Access Compliance Report

Public Rights-of-Way

Intersection ID: 14213	Main Street: CENTRAL_AV	Cross Street: ROSEHAVEN_DR	Location: SW
ADA ID: 3BFCA5398980	Ramp Type: BlendTrans1	Initial Pass/Fail: Fail	Overall Compliance: No
		Severity Score: 10

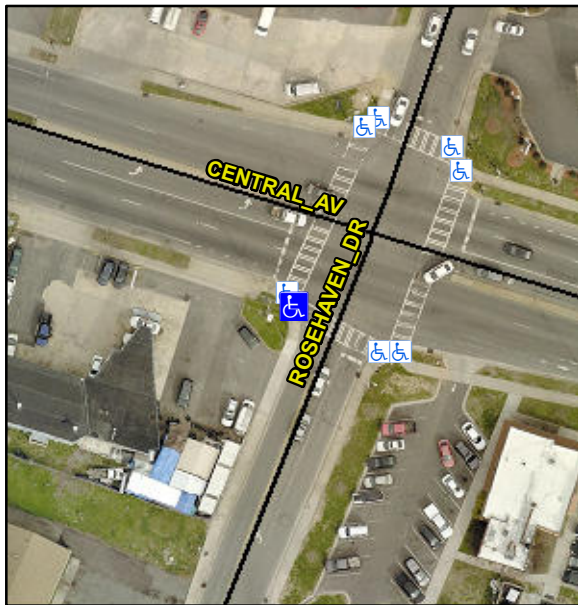
Not Found, R304.5.1

Compliance	Description	Data	Compliance	Description	Data
N/A	Ramp Length (in)	71.5	Yes	BlendTrans Slope (%)	3.3
No	Ramp Width (in)	39.5	Yes	BlendTrans XSlope (%)	4.1
N/A	Flare Type LT	N/A	N/A	Flare Type RT	N/A
N/A	Flare Slope LT (%)	N/A	N/A	Flare Slope RT (%)	N/A
N/A	Flare Traversable LT?	N/A	N/A	Flare Traversable RT?	N/A
N/A	Landing Length (in)	N/A	N/A	DWS Provided?	N/A
N/A	Landing Width (in)	N/A	N/A	DWS Contrast?	N/A
N/A	Landing Slope (%)	N/A	N/A	DWS Length (in)	N/A
N/A	Landing X Slope (%)	N/A	N/A	DWS Full Width?	N/A
N/A	Landing Curb? (Y/N)	N/A	N/A	DWS Offset (in)	N/A
N/A	Shared Landing?	N/A			
N/A	Gutter Ponding?	N/A	N/A	Gutter Slope (%)	N/A
N/A	Gutter Lip Ht (in)	N/A	N/A	Gutter X Slope (%)	N/A
N/A	Painted X Walk1?	Yes	N/A	Painted X Walk2?	N/A
	X Walk 1 Direction	To SE		X Walk 2 Direction	N/A
	X Walk 1 Width (in)	108.0		X Walk 2 Width (in)	N/A
	X Walk 1 Slope (%)	1.1		X Walk 2 Slope (%)	N/A
	X Walk 1 X Slope (%)	4.2		X Walk 2 X Slope (%)	N/A

N/A	Ramp inside XWalk1?	Yes	N/A	Ramp inside XWalk2?	N/A
	Road Slope (%)	4.2		Clear Space?	N/A
	Road X Slope (%)	1.1	N/A	Clear Space to XWalk (in)	N/A
N/A	Any Obstructions?	N/A	N/A	Storm Grate/Utility Hazard?	N/A
	Obstruction Type			Storm Grate/Utility Type	
		N/A			N/A
			Yes	Surface Condition? (G/P)	Good
			No	Curb Slope (%)	26.4

Remove & Replace Curb Ramp With Two New Directional Ramps or Equivalent.
